# UNITED STATES PATENT AND TRADEMARK OFFICE

APPLICATION NO.	FILING DATE	FIRST NAMED INVENTOR	ATTORNEY DOCKET NO.	CONFIRMATION NO.
10/663,755	09/17/2003	Sterling Smith	MSS0007-US	3830
7590 Michael D. Bednarek Shaw Pittman LLP 1650 Tysons Boulevard McLean, VA 22102		03/01/2007	EXAMINER NGUYEN, HIEP	
			ART UNIT 2816	PAPER NUMBER
SHORTENED STATUTORY PERIOD OF RESPONSE		MAIL DATE	DELIVERY MODE	
3 MONTHS		03/01/2007	PAPER

<b>Office Action Summary</b>	<b>Application No.</b> 10/663,755	<b>Applicant(s)</b> SMITH, STERLING	
	<b>Examiner</b> Hiep Nguyen	<b>Art Unit</b> 2816

### **DETAILED ACTION**

Fig 3

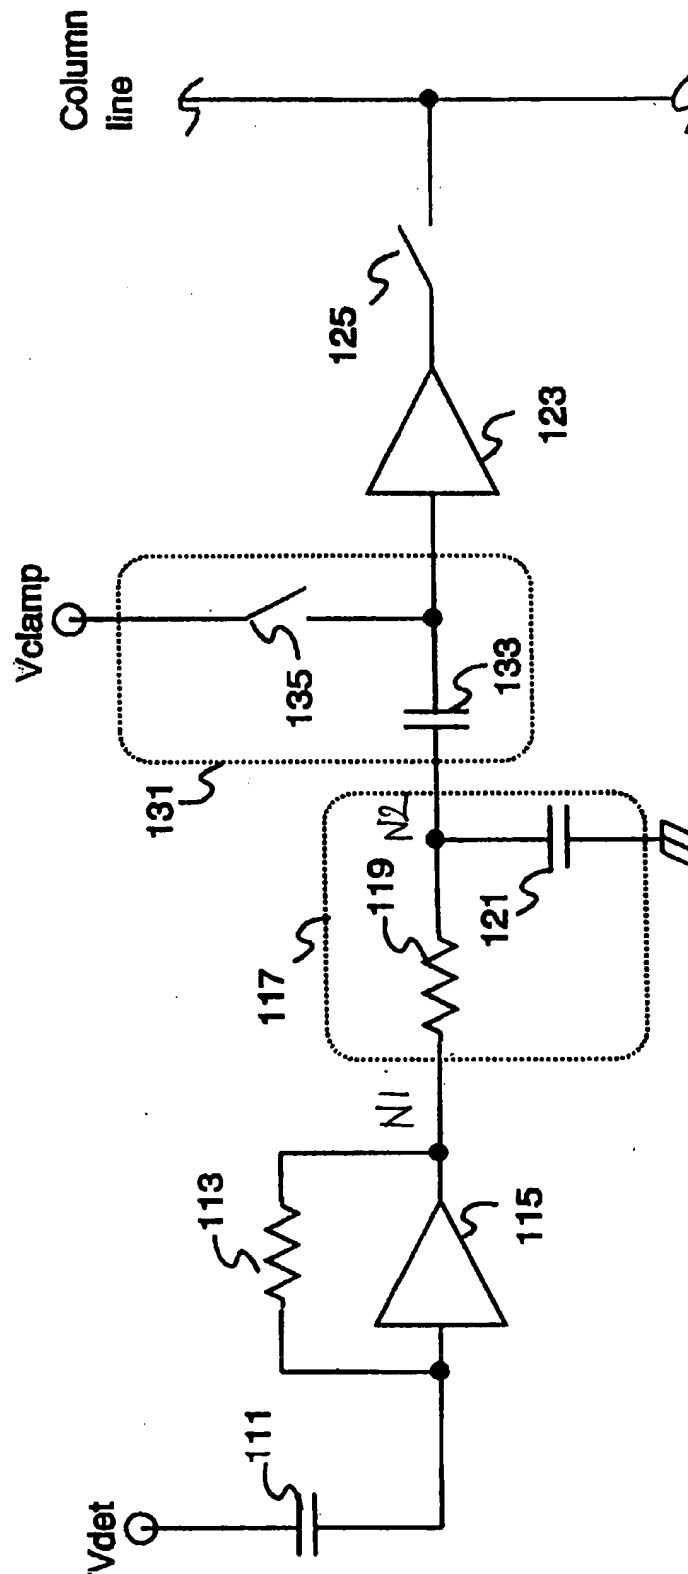
Claims 19 and 23 are rejected under 35 U.S.C. 102(b) as being anticipated by Peterson et al. (US 5,926,217). See attachment.

Regarding claim 19, figure 3 of Peterson shows an electronic circuitry, comprising: a first capacitor (111) for capacitively coupling an analog image signal (Vdet) to a first node (N1); a resistor (119) electrically connected between said first node (N1) and a second node (N2); a second capacitor (121) electrically connected between said second node (N2) and a ground node; and a switching device (135) connected between said second node and a reference level (Vclamp); wherein said resistor and said second capacitor form a filter for processing said analog image signal and providing a processed image signal at said second node, and said switching device is controlled by a clamping signal, not shown, to clamp said second node at a clamping voltage (Vclamp) with reference to said reference level during a clamping interval. The switching device (135) that is equivalent to the switching device (M9) in figure 4 is a transistor having a drain connected to the internal node, a source connected to the reference voltage and a gate controlled by a clamping signal (Vclmp).
